AMENDED FINAL DEVELOPMENT PLAN

FOR JIMMY JOHN'S

121 SOUTHGATE DRIVE
GEORGETOWN, KENTUCKY 40324
(AMENDS FDP APPROVED 08/2020)

SUMMARY OF AMENDED PLAN CHANGES

AMENDED SITE PLAN

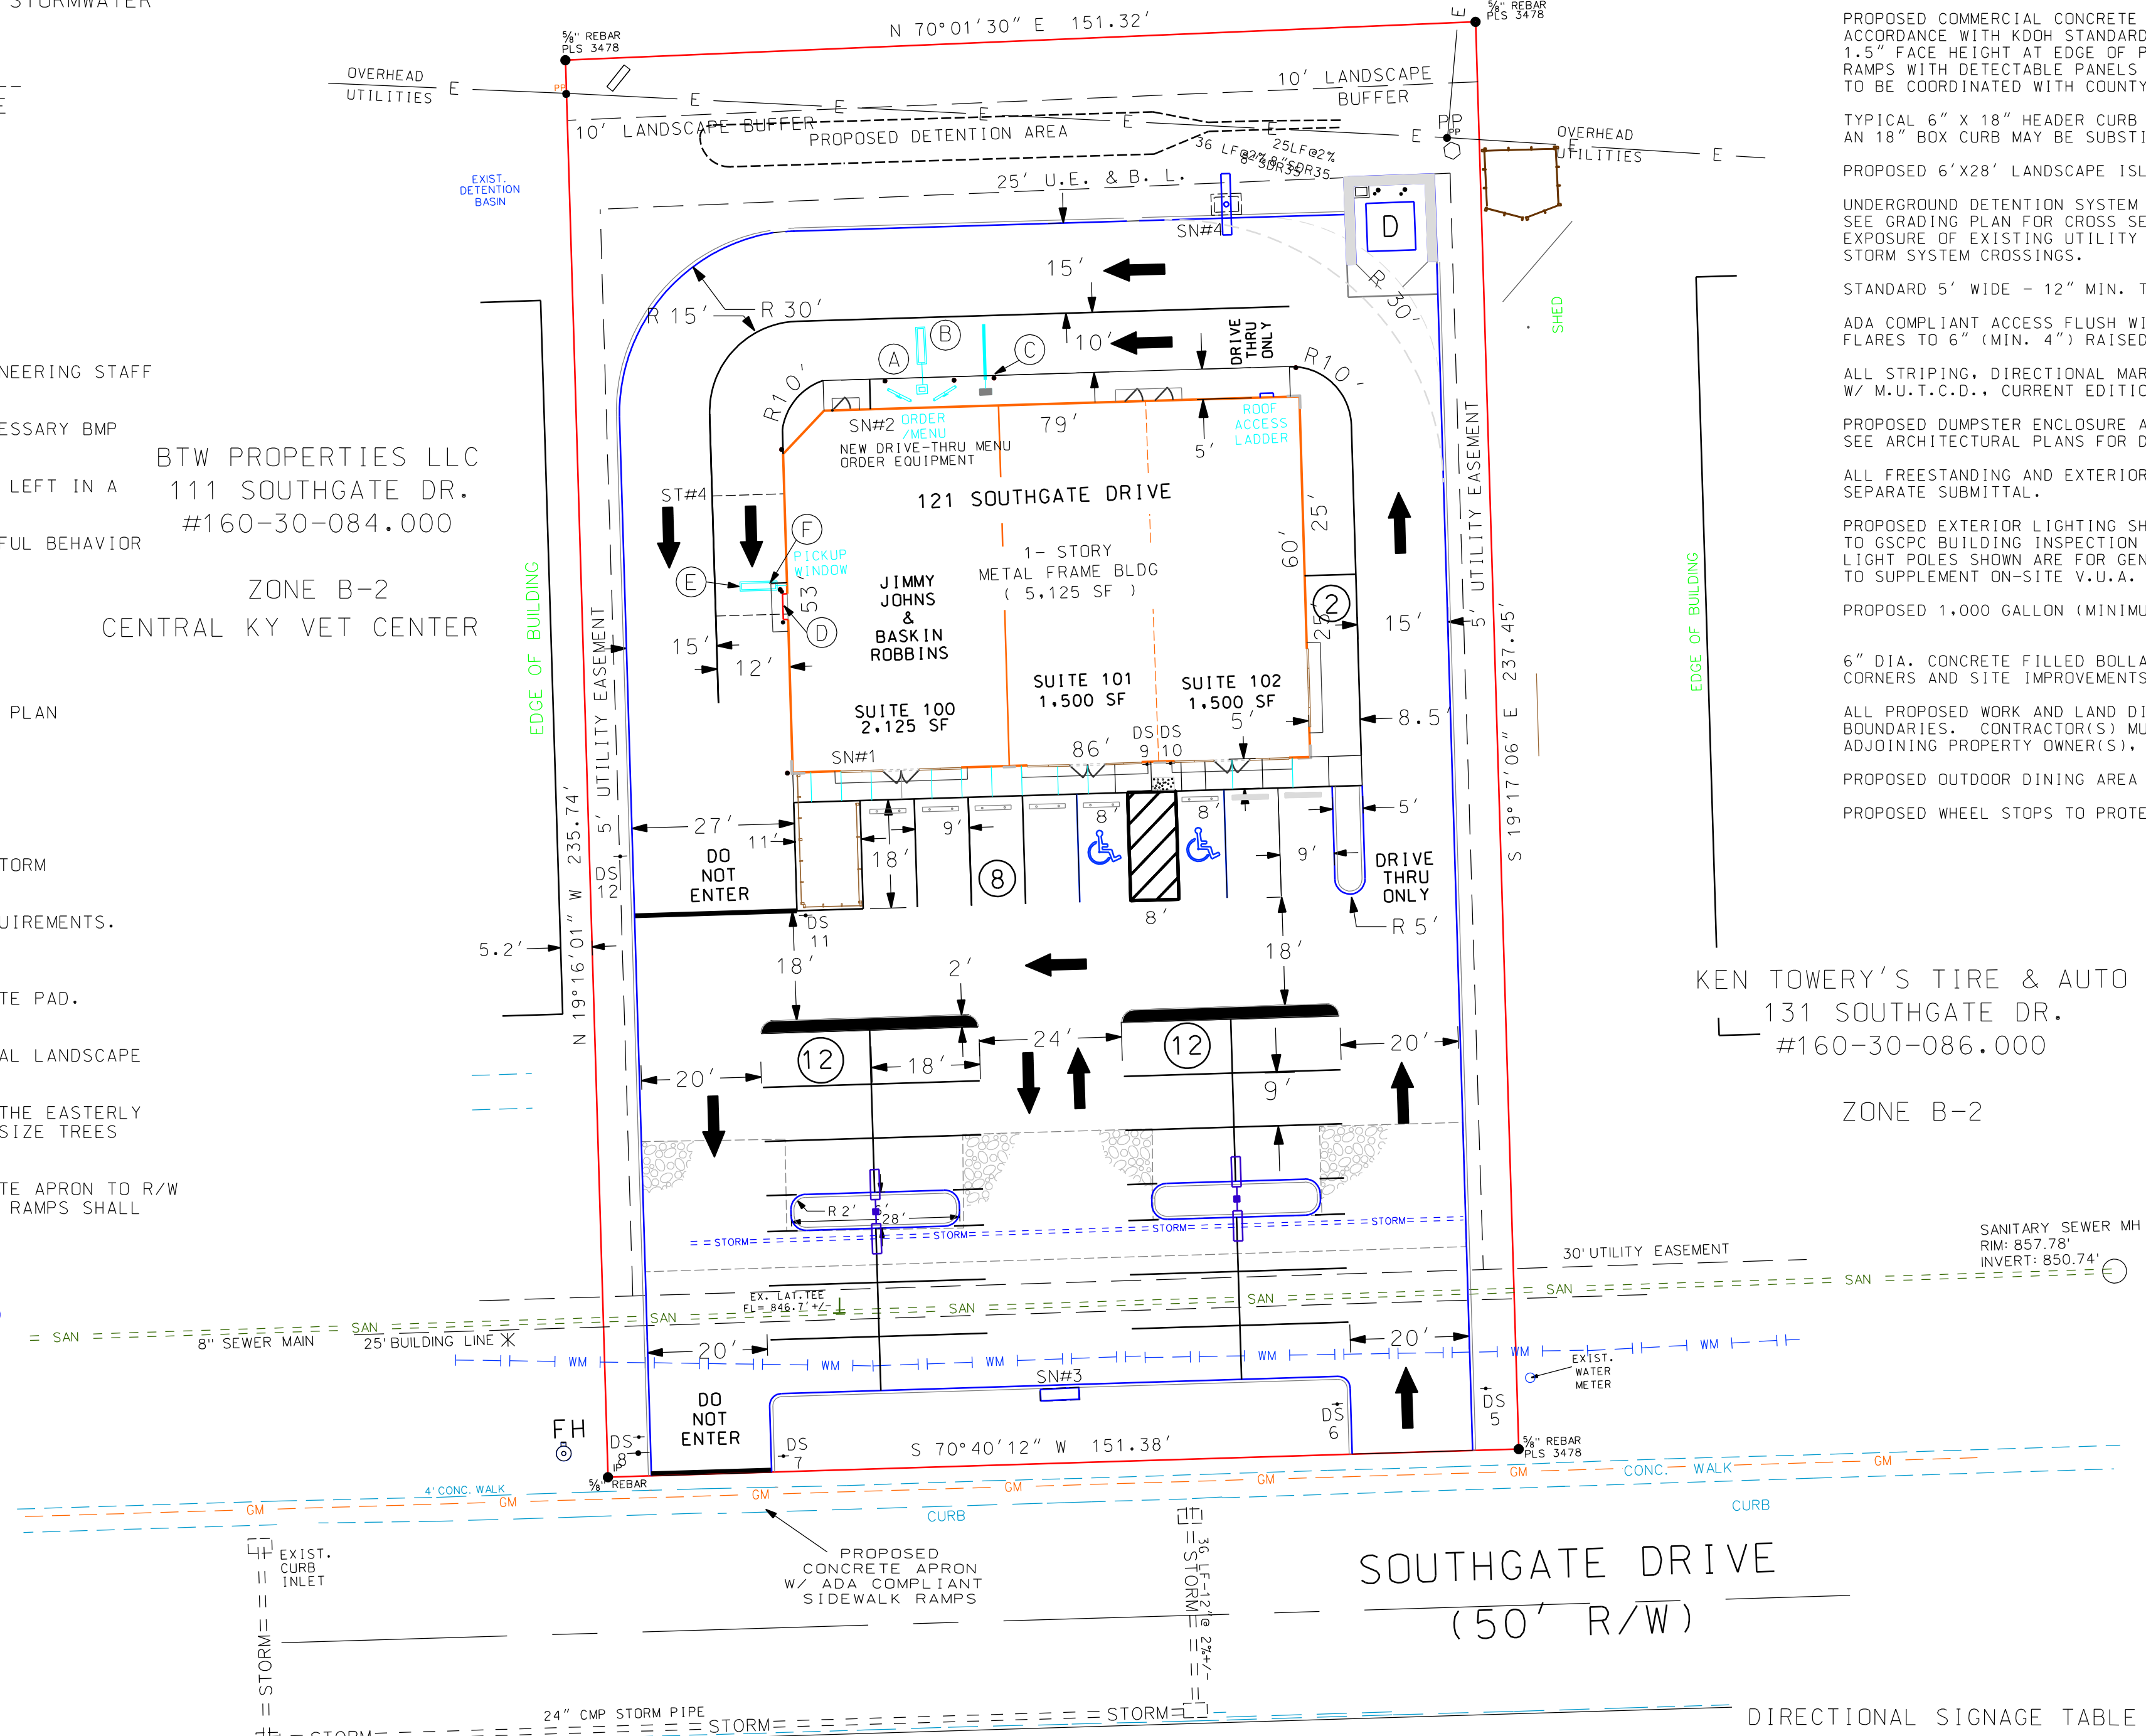
- 1) RECONFIGURED FRONT PARKING AREA FOR ONE-WAY TRAFFIC FLOW.
- 2) SECOND ACCESS POINT ADDED FOR ONE-WAY TRAFFIC LAYOUT. WIDER SINGLE LANE WIDTH USED FOR ENHANCED DRIVER COMFORT AND LARGE VEHICLE TURNING MOVEMENT OPERATION.
- 3) EXPANDED SIDEWALK CONSTRUCTION BETWEEN NEW ENTRANCE AND POINT REPAIR TO ELIMINATE SHORT REMNANT SECTION.
- 4) ADDED OUTDOOR SEATING AREA.
- 5) RELOCATED DRIVE-THRU MENU BOARD AND ORDER LOCATION.

AMENDED LANDSCAPE PLAN

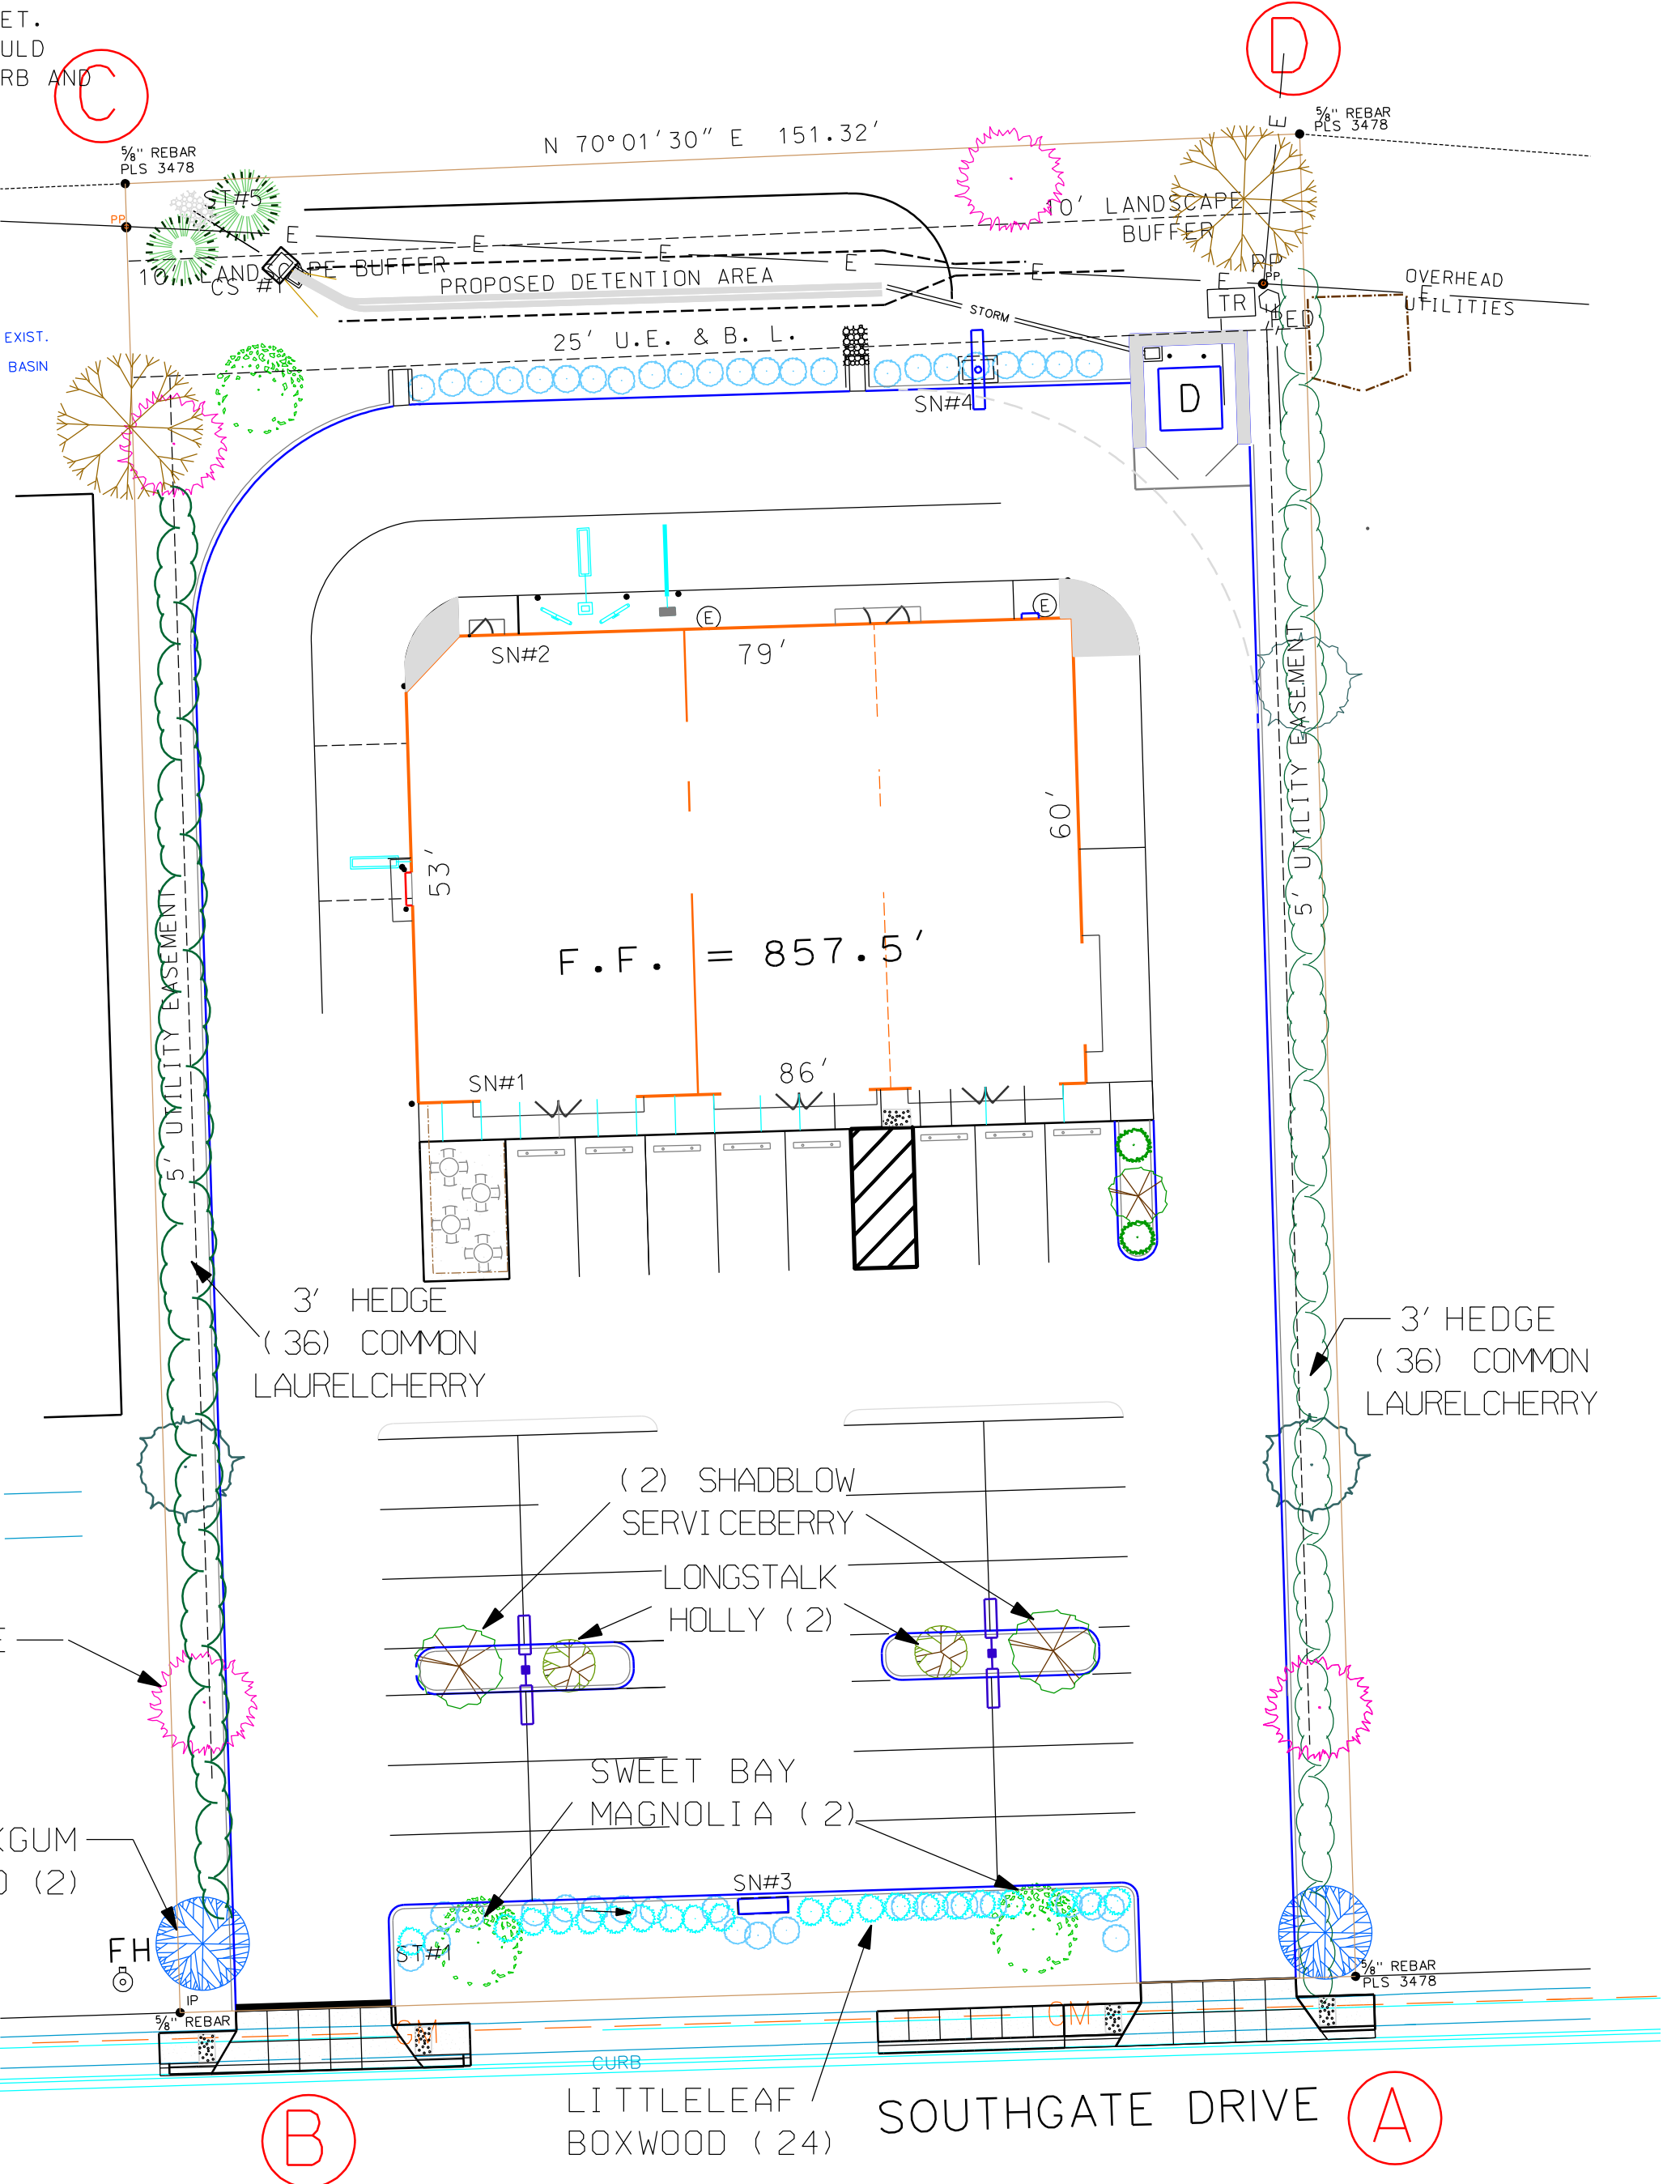
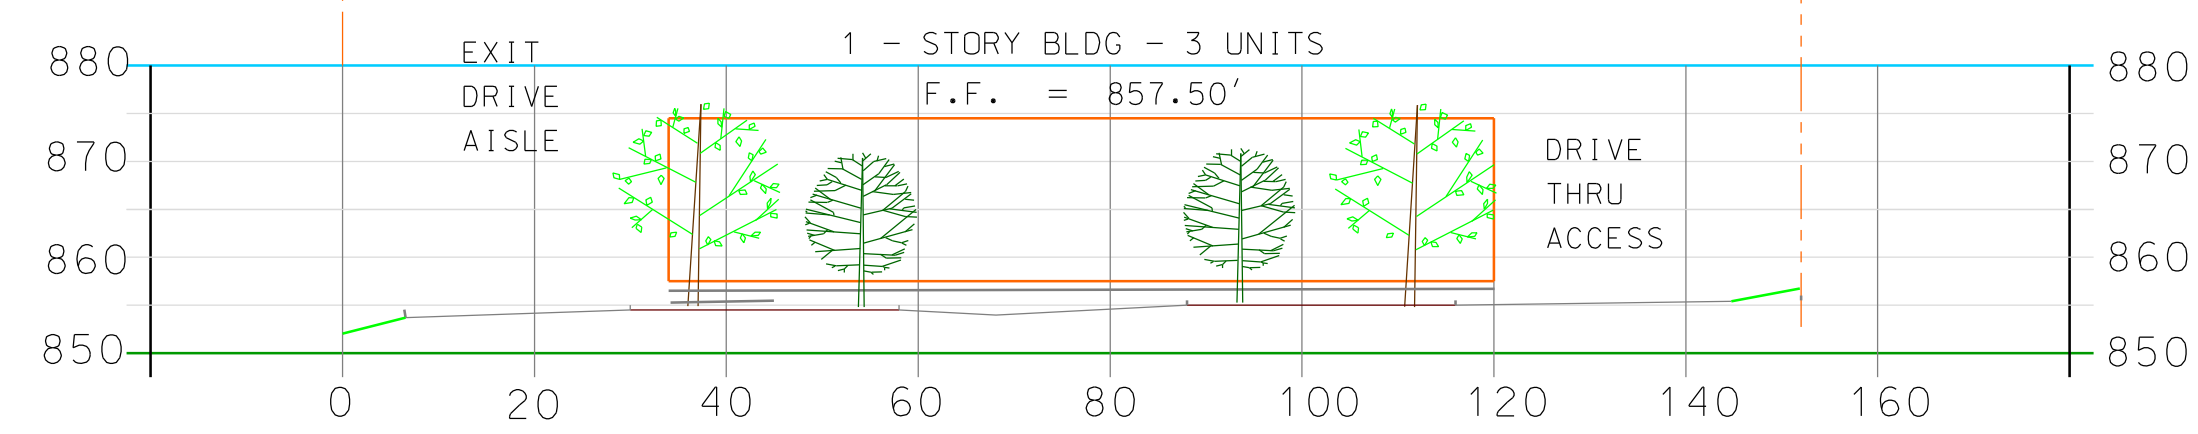
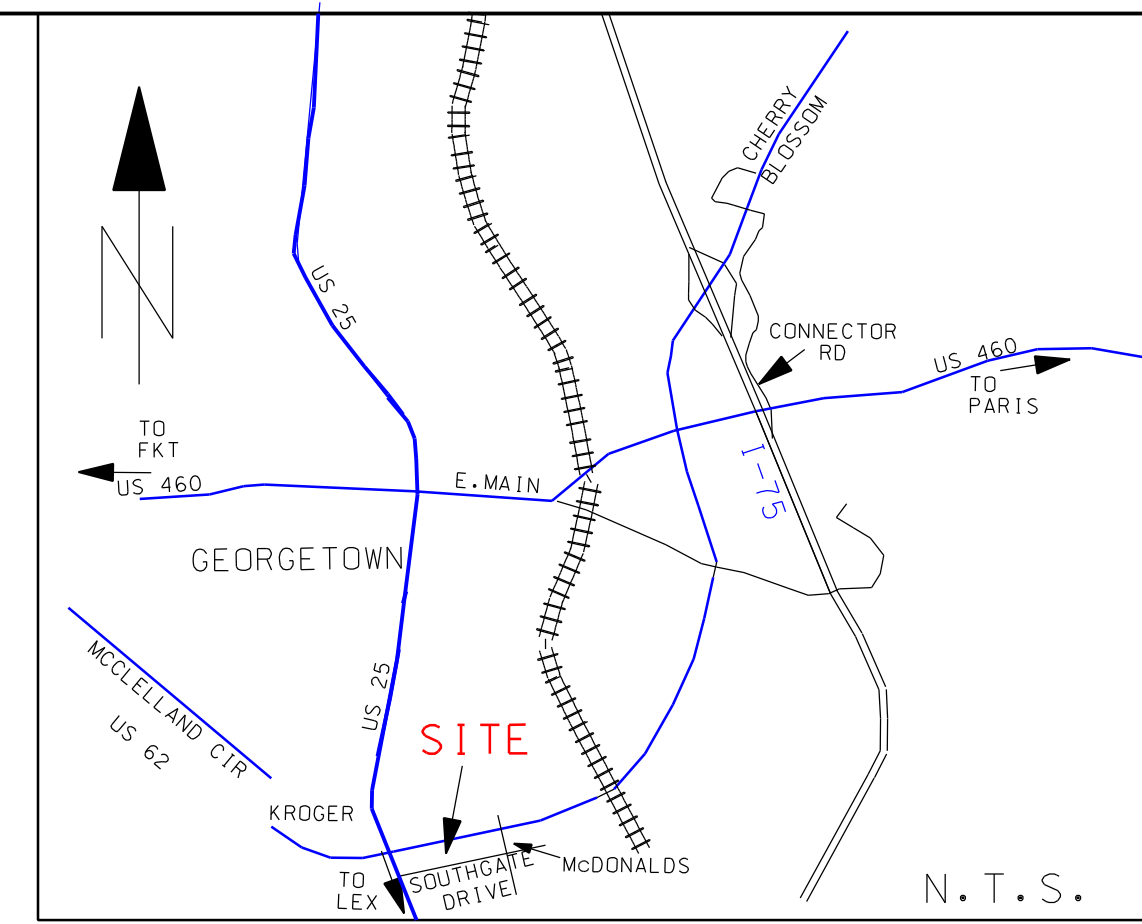
- REWORKED FRONT PARKING AREA LAYOUT.
- REVISED PERIMETER AND INTERIOR LANDSCAPING REQUIREMENTS.
- ADDED NOTE(S) FOR CREDITING EXISTING ACCEPTABLE PLANTINGS AND SCREENING ON ADJACENT COMMERCIAL PARCELS.
